MUAZUDDIN TEXTILE LTD (Extension 3)

21 April 2024

B+G+2: Chemical & Fabric Store Building.

Observation-3: Falling hazard at the roof and lift core (Chemical & Fabric Store Building).

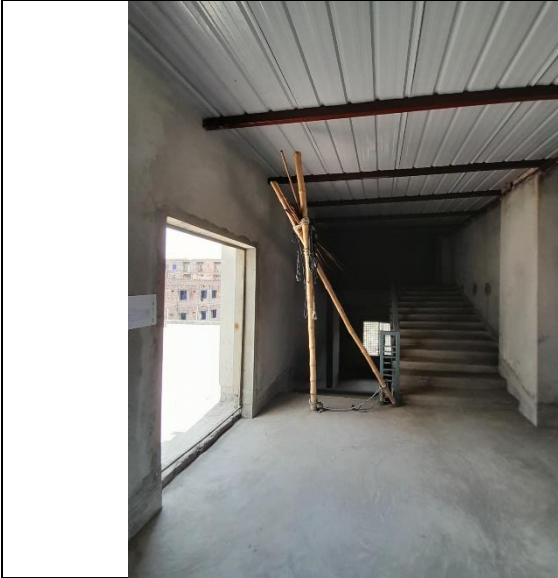
Description: Parapet and safety barrier not provided on the roof and around the lift core. Building engineer is required to provide a safety barrier to prevent the falling hazard.
